Subject: Duke Energy Carolinas, LLC
William States Lee III Nuclear Station - Docket Nos. 52-018 and 52-019
AP1000 Combined License Application for the William States Lee III Nuclear
Station Units 1 and 2
Response to Request for Additional Information Letter No. 120 (eRAI 7570)
Ltr#: WLG2014.08-01

Reference: Letter from Brian Hughes (NRC) to Robert Kitchen (Duke Energy), Request
for Additional Information Letter No. 120, Related to SRP Section 03.07.02 –
Seismic System Analysis for the William States Lee III Units 1 and 2
Combined License Application, dated July 11, 2014 (ML14192B073)

RAI 03.07.02-3 (eRAI 7570)

Reference NRC RAI Number(s): 03.07.02-3 (eRAI 7570)

Figure 03.07.02-3-4 - ASB at Northeast Corner (Elevation 134.5')

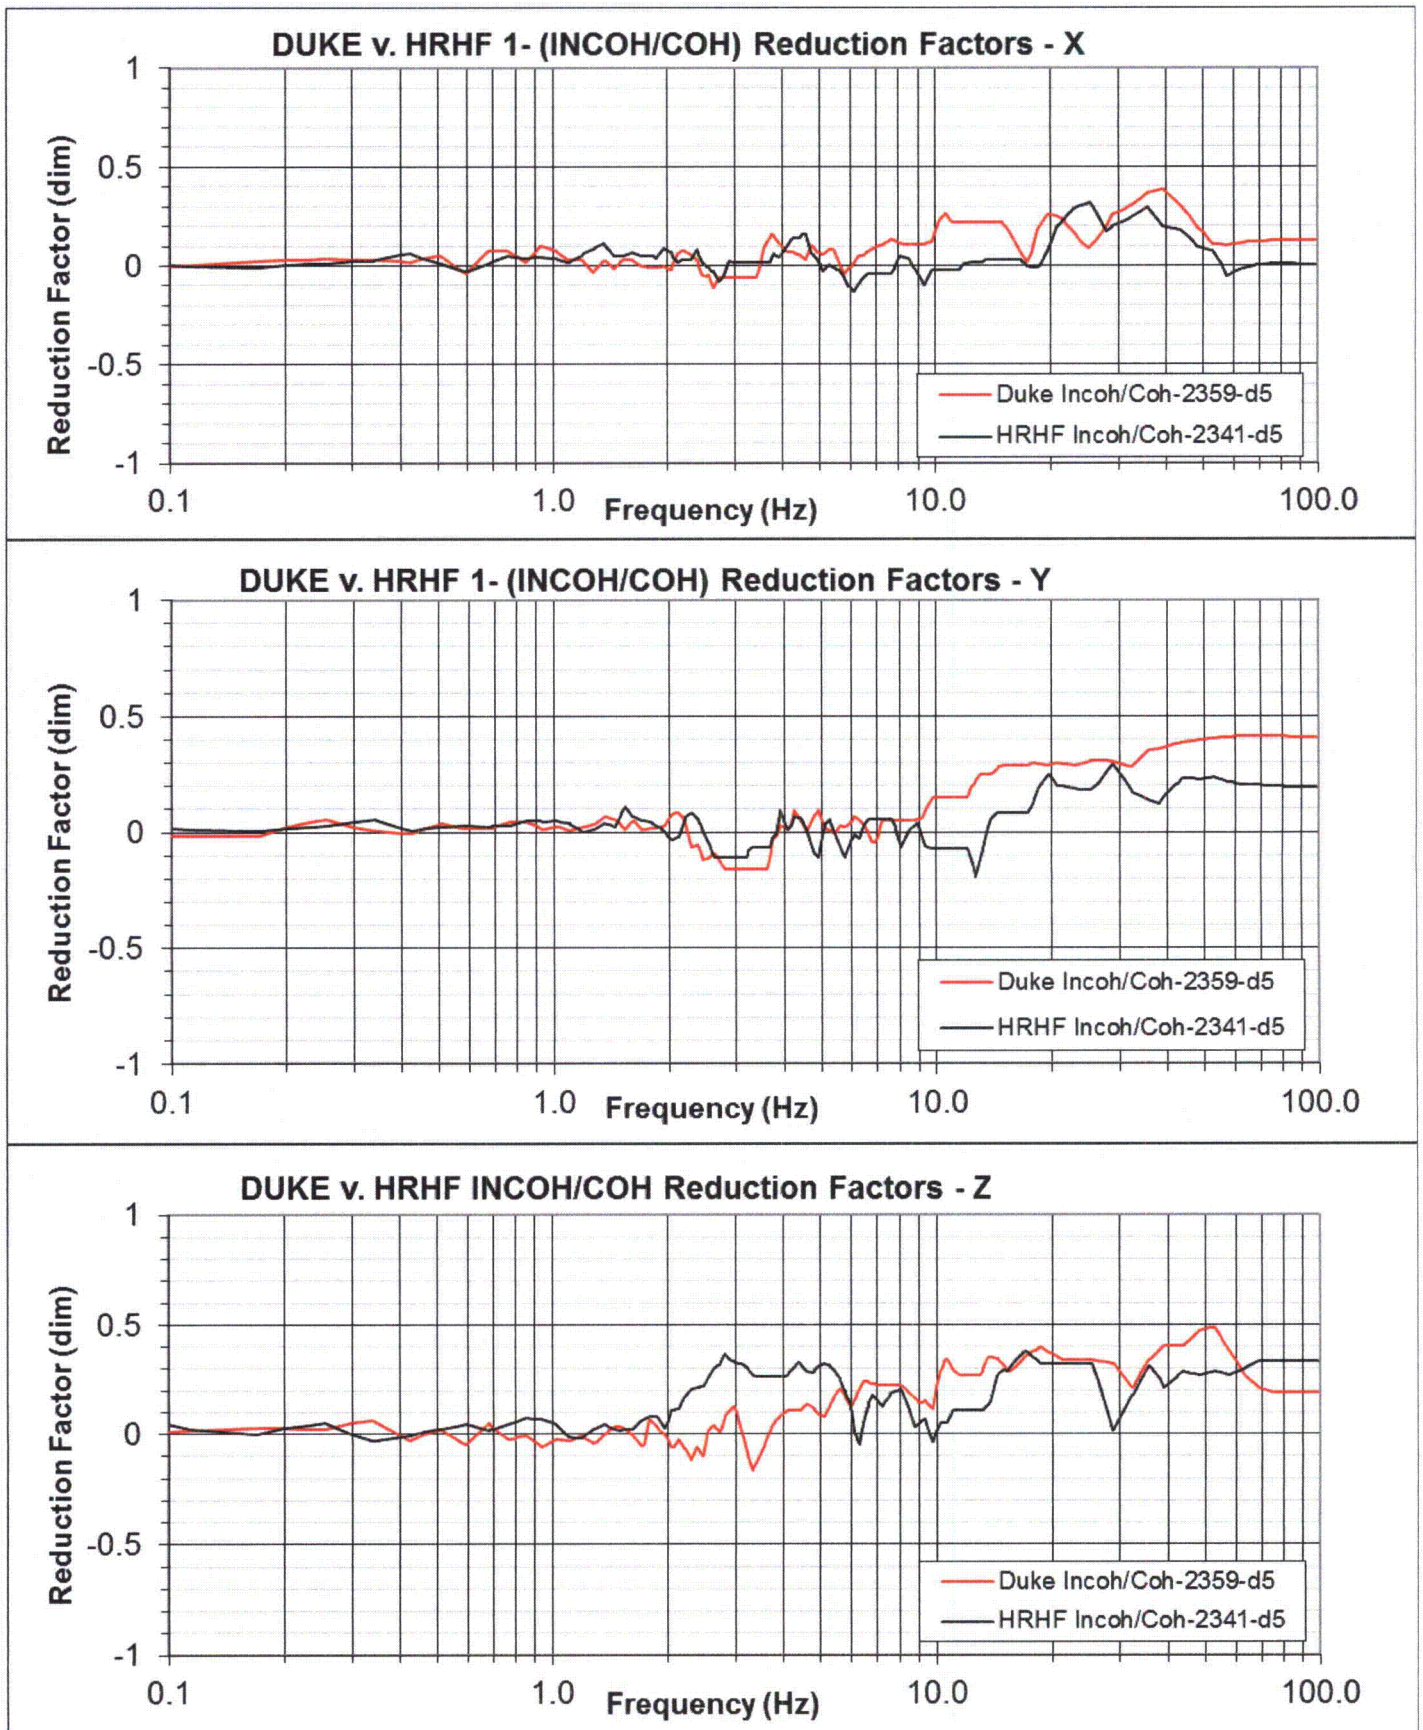
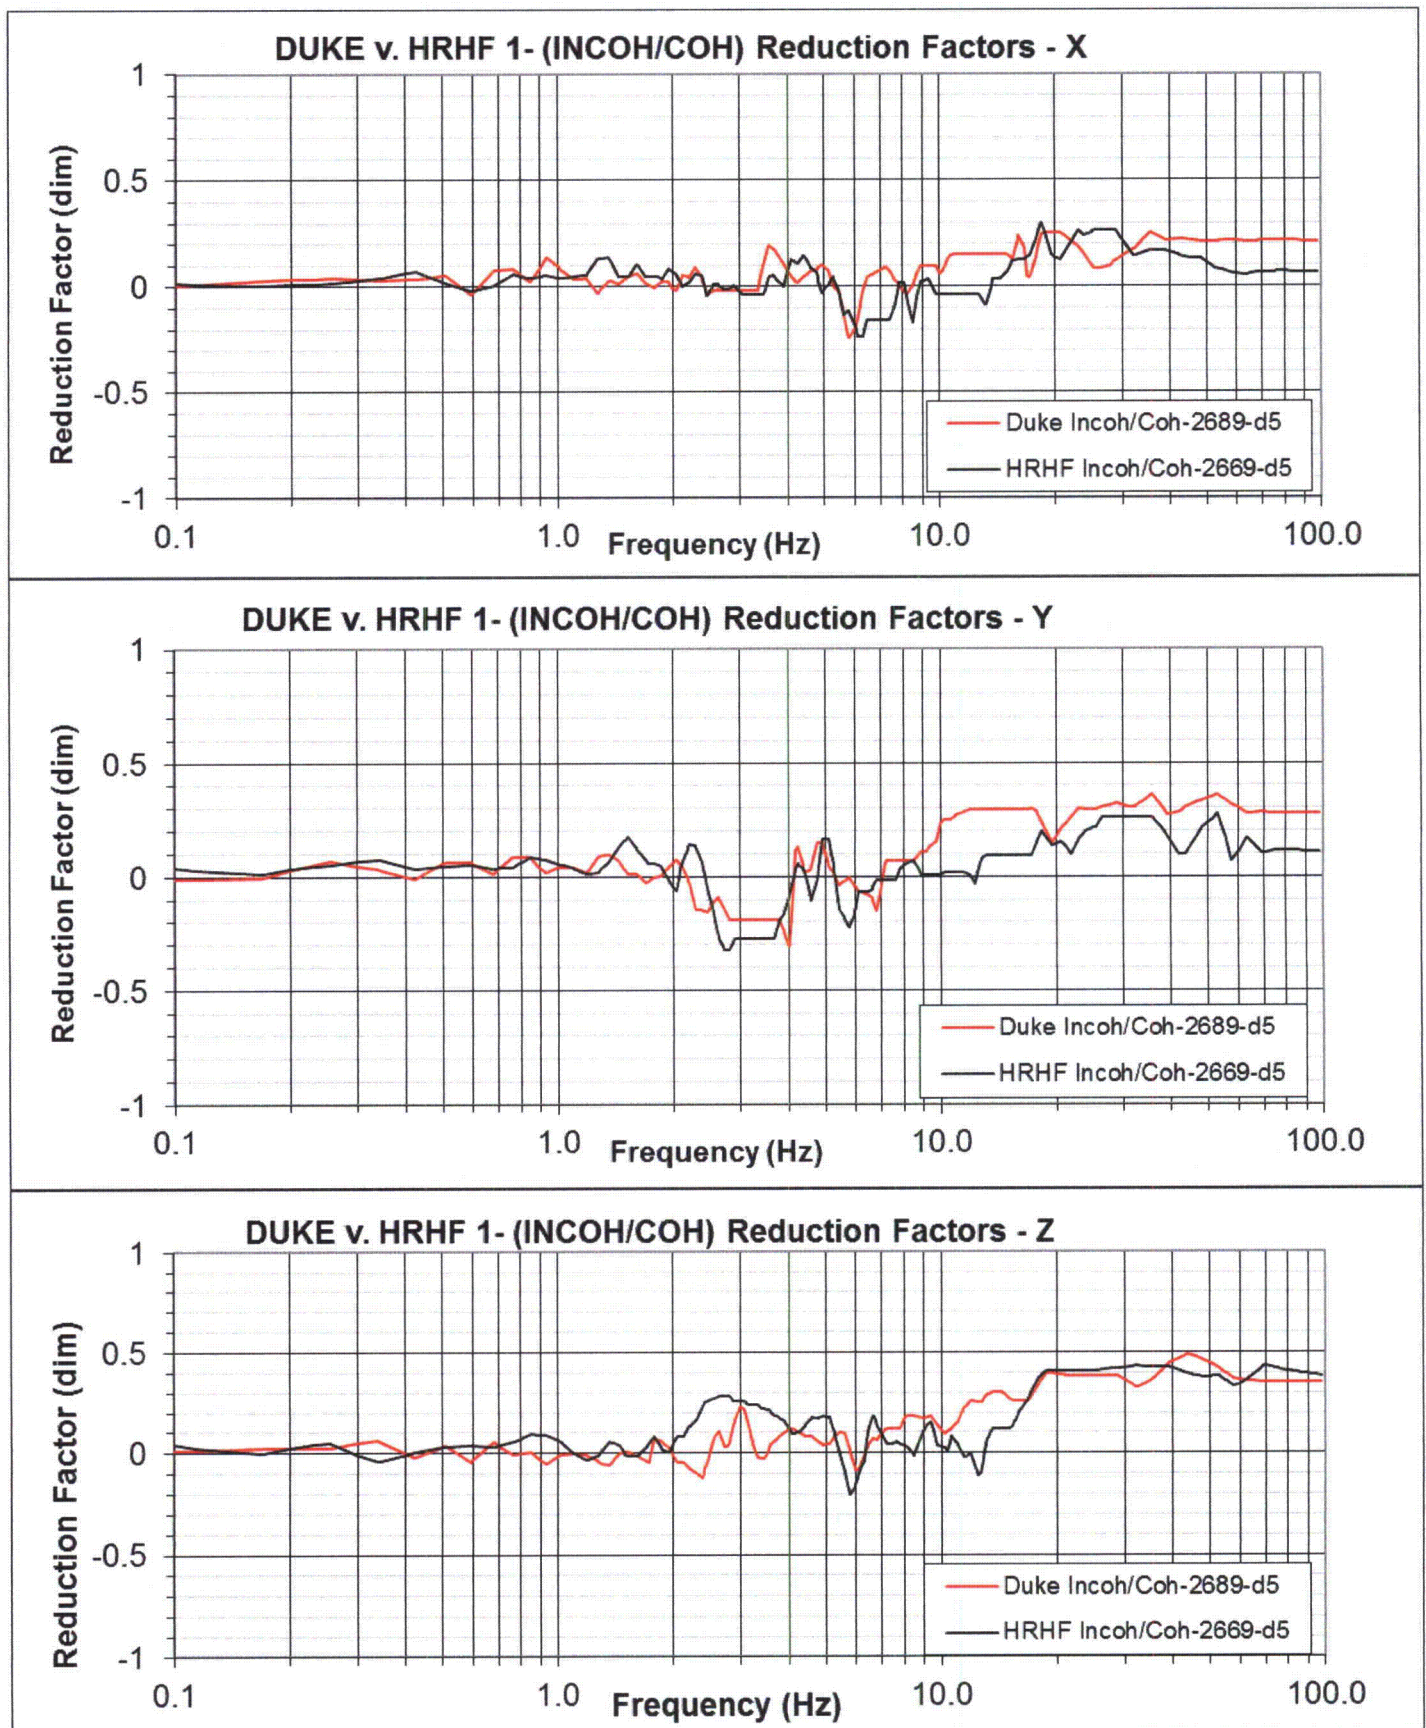
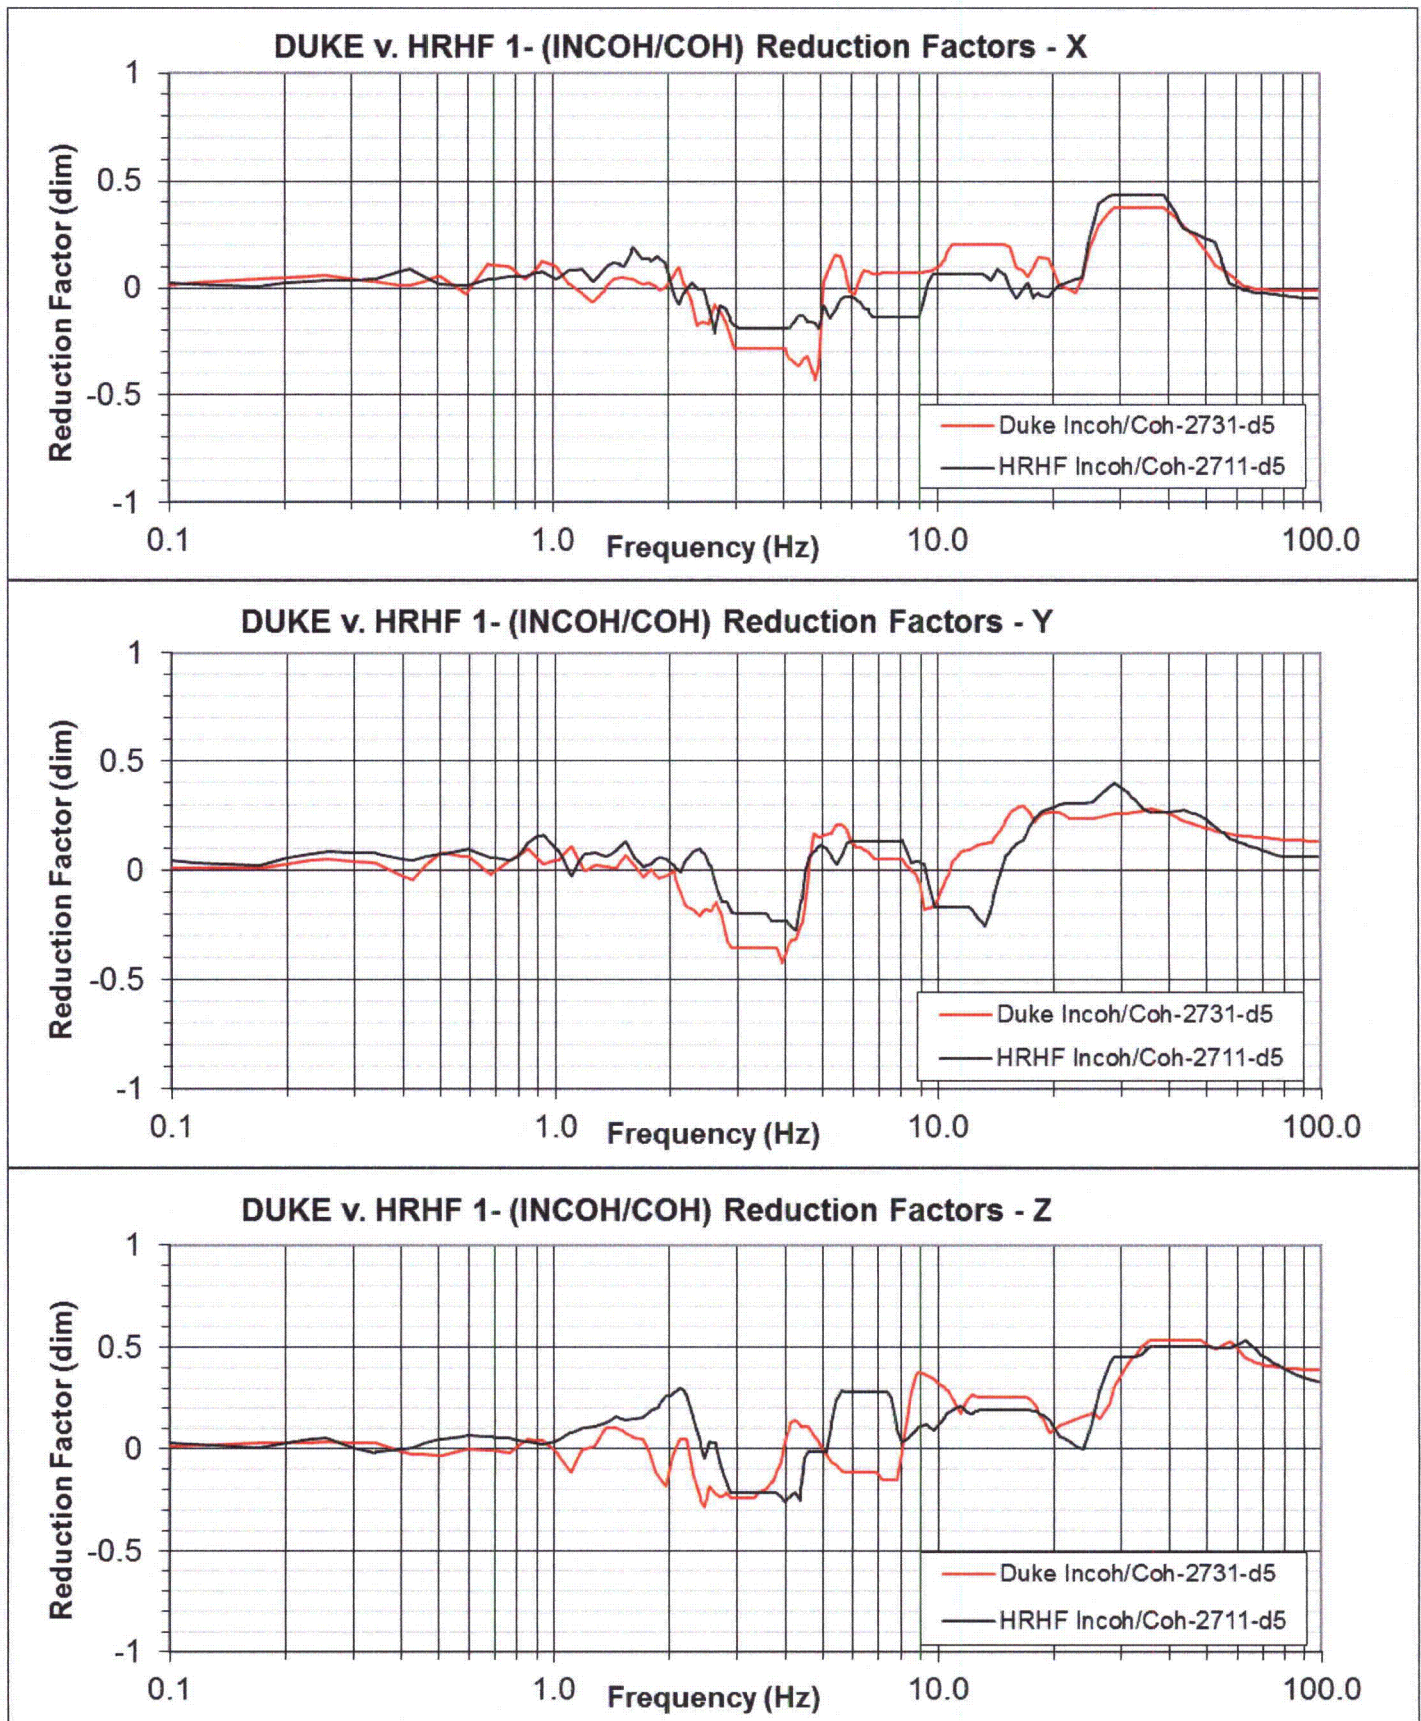
Staff review of Duke Ltr#WLG2014.01-02 Appendix A to WLG-GW-GLR-815 Rev 0 finds that while the graphical comparisons are helpful in assessing the impacted frequency ranges due to incoherency, they do not indicate the percentage reduction of coherent motion; $[1 - (\text{incoherent response} / \text{coherent response})] \times 100\%$.

To assist the staff in its review of the site-specific implementation of seismic motion incoherency, the applicant is requested to quantify the range of reductions to coherent motion for both the AP1000 HRHF and site-specific evaluations.

The following summarizes the data presented below in Figures 03.07.02-3-1 through 03.07.02-3-9:

- The Duke Lee and AP1000 TR115 FRS coherent reductions are comparable for the NI nodes and directional FRS presented. Reduction factors trend similarly in shape and magnitude, and reduction factor differences, both positive and negative occur for both Duke Lee and AP1000;
- Duke Lee and AP1000 TR115 FRS incoherent reduction factor differences are influenced by model refinements to the NI20u finite element model for Duke Lee versus the AP1000 NI20r model to reflect the latest design; and;

- Rock profile differences between the AP1000 generic hard rock profile and the site-specific Duke Lee concrete/rock profiles, i.e., lower shear wave velocity (V_s) in the 50' below basemat.

In conclusion, the Duke Lee and TR115 FRS coherent reductions are similar given the variations in Duke Lee versus AP1000 site conditions and the seismic model updates.
